910-938 Custer Avenue Planned Development – Pre-Application Conference

Project: 910 – 938 Custer Avenue

Project No.: 23-429

Response Date: 07.31.24

FLOOR/CEILING - 2HR WOOD FRAMING

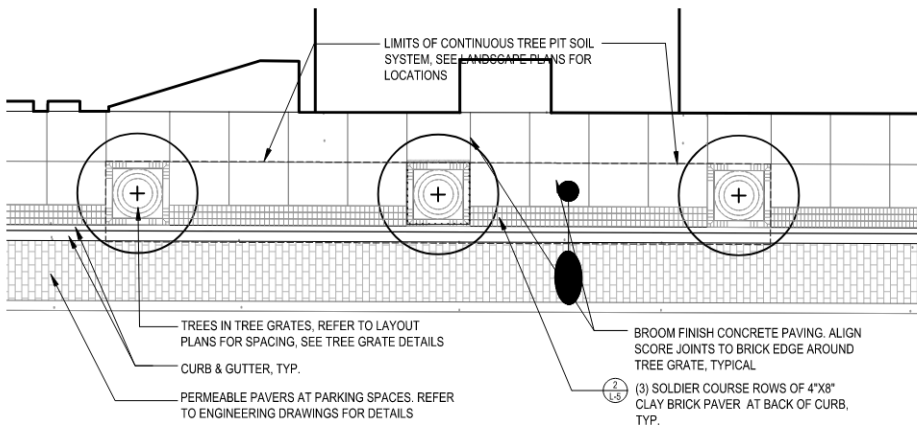
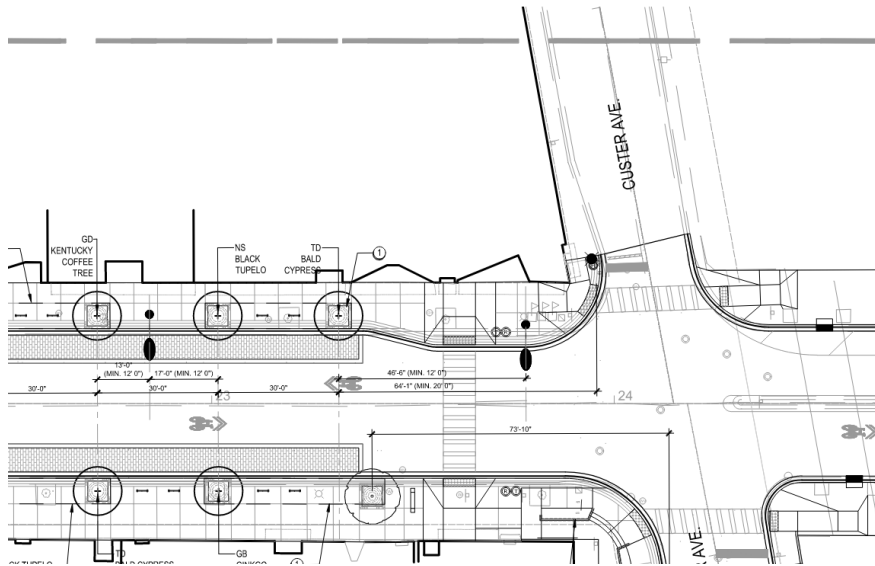
1. Provide a massing study that shows the height and bulk of surrounding buildings in the area. Include the train embankment and buildings east of the train tracks.
 - **Answer: Renderings with the massing of the building east of the train tracks have been included in the main set of drawings.**
2. Provide details of EIFS material anticipated for front façade including weathering/moisture details for this climate that ensure the material is high quality for a primary façade.
 - **Answer: EIFS Product Data attached to this document. We will provide during the design process a detail similar to the attached.**
